February 16, 2024

RE: Responses to School Board Questions dated 1-29-24
Via: Email to szdravec@sau50.org

The following, in bold font, are my team's responses to the Rye School Board's list of questions received on January 29, 2024:

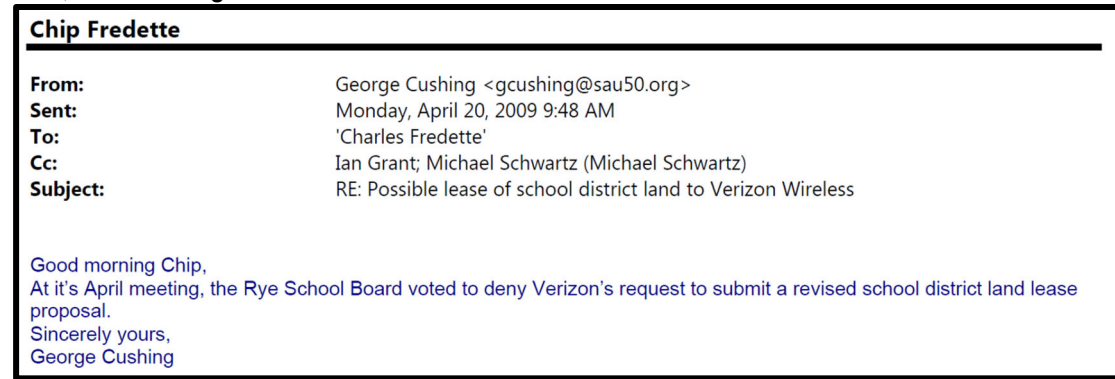
1.) What is the proposed distance between the tower and RES?

2.) What is the proposed distance between the tower and the upper playground?

3.) What is the proposed distance between the tower and the outdoor classroom spaces?

RESPONSE: Approximately 420'.

RESPONSE: Approximately 271'.

RESPONSE: Approximately 48'.
